EMERGENCY DROUGHT APPLICATION: GROUNDWATER REVIEW

TO: Water Rights Section Date 7/13/2026
FROM: Groundwater Section Grayson Fish
Reviewer's Name
SUBJECT: Application G- 19544

KLAMATH COUNTY DROUGHT MITIGATION; GROUNDWATER

A. GENERAL INFORMATION: Applicant's Name: Twelve K's Cattle, LLC County: Klamath

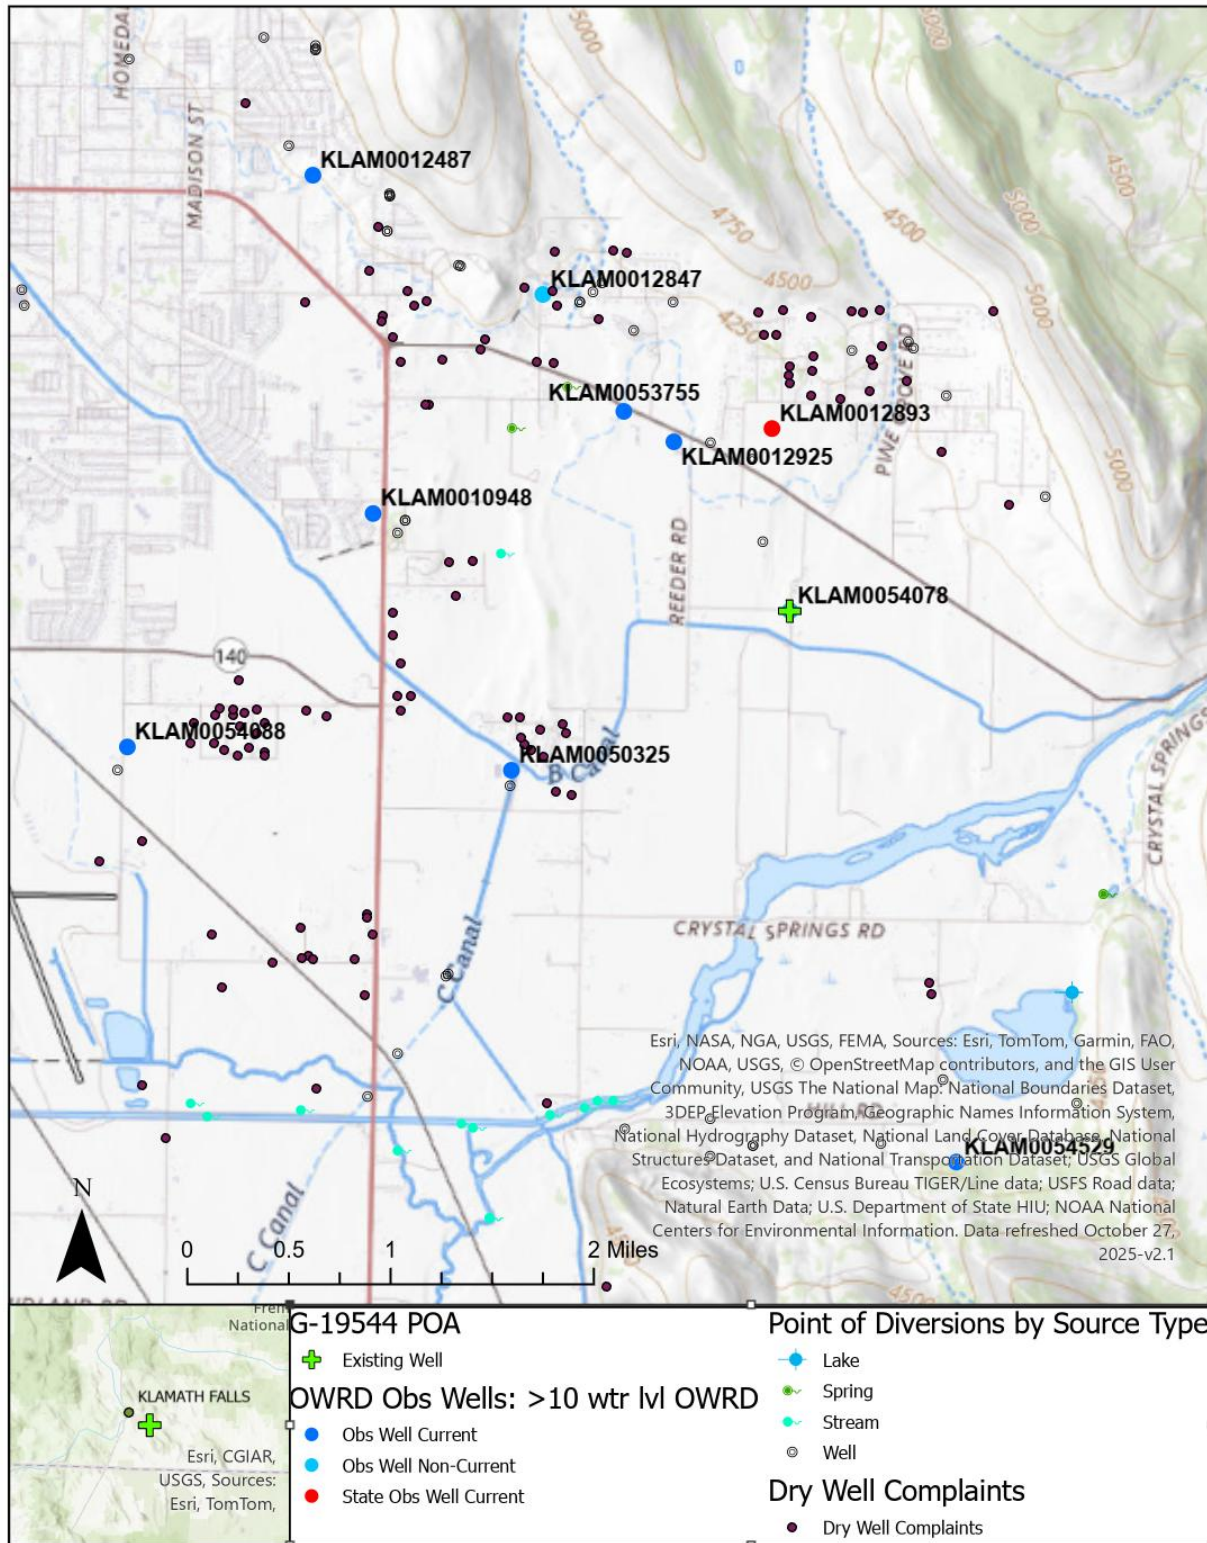
B1. Is there information that this drought groundwater use will **injure senior spring or surface water rights** during the duration of the drought declaration?
(☐Yes) (☒No) If yes, explain: The applicant's well would access groundwater from volcanics starting at a depth of approximately 1,374 feet. The closest surface water source is likely the Lost River approximately 1.25 miles to the south and the closest hydraulically connected spring source is Crystal Springs located approximately 2 miles to the southwest. Given the distance to the identified surface water/spring sources, depth of groundwater to be accessed, and the presence of low permeability fine-grained sediments overlying the volcanic units, it is unlikely that senior spring or surface water rights are likely to be injured by the proposed use during the drought declaration period.

- B2. Is there information that this drought groundwater use will **injure senior groundwater rights** during the duration of the drought declaration?
(☐Yes) (☒No) If yes, explain: The closest volcanic wells to the applicant's POA are other irrigation wells and exempt wells located to the north within residential areas of Pine Grove. Irrigation wells that source water from volcanics are unlikely to experience injury due to the thickness and relatively high transmissivity of the aquifer. There have been approximately 50 dry or low production complaints received by the Department since 2021 in the residential areas north of the applicants POA where many of the wells source water from volcanics. However, these wells do not fully penetrate the aquifer and any interference experienced from additional pumping from the applicants POA during the duration of the drought declaration is unlikely to meet the definition of injury.

Water-Level Measurements in Nearby Wells
Area Hydrograph

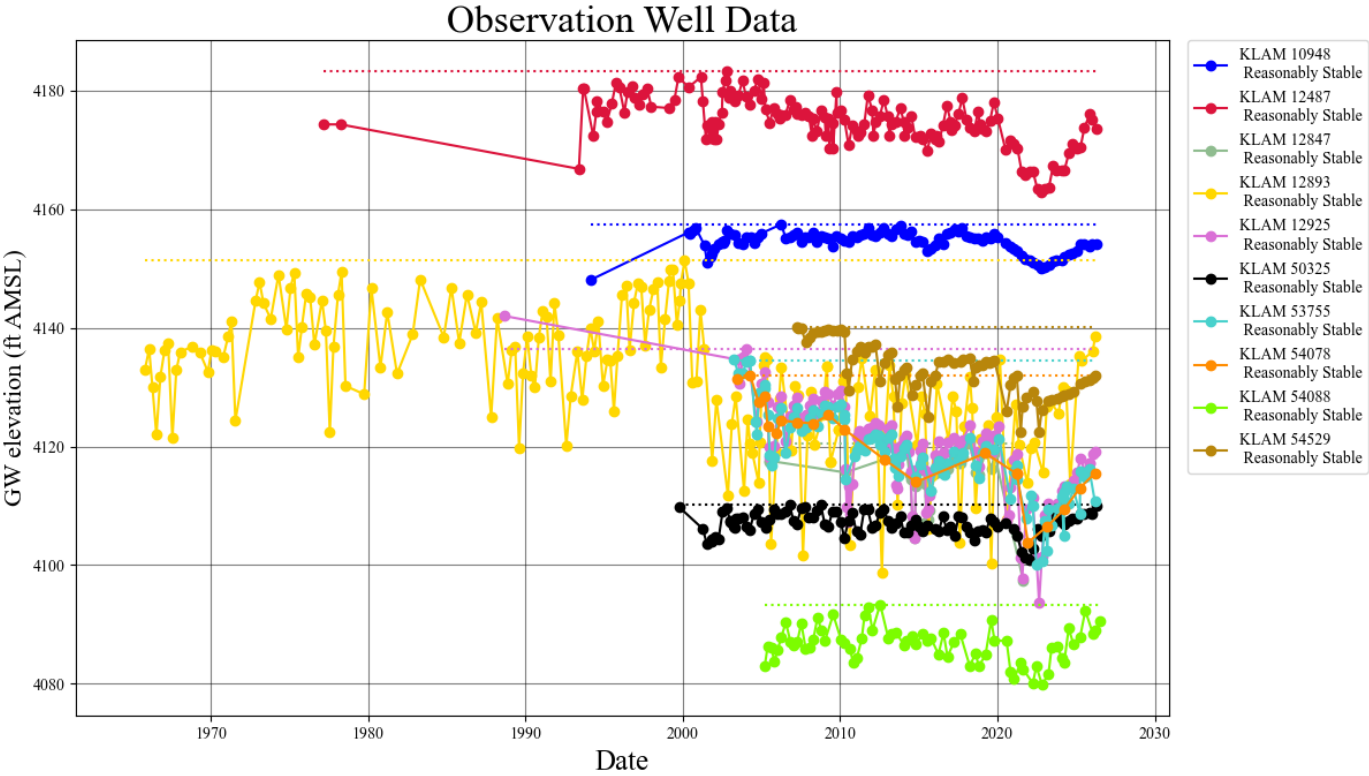
-
- B3. Has the requested groundwater reservoir or part thereof **Declined Excessively**?
(☐Yes) (☒No) If yes, explain: Of the 10 observation wells regularly measured by OWRD staff within 2 miles of the applicant's POA, none of the wells in either the volcanic or sedimentary portion of the aquifer show a total decline of 50 feet or more over their period of record (see attached Area Hydrograph).
-

-
- B4. Groundwater levels **do NOT meet the definition of Reasonably Stable Groundwater Levels** (including insufficient data):
(☐ Yes) (☐ No) If yes, explain: All of the 10 observation wells regularly measured by OWRD staff within ~3 miles of the applicant's POA meet the definition of reasonable stable (see attached Area Hydrograph).
-
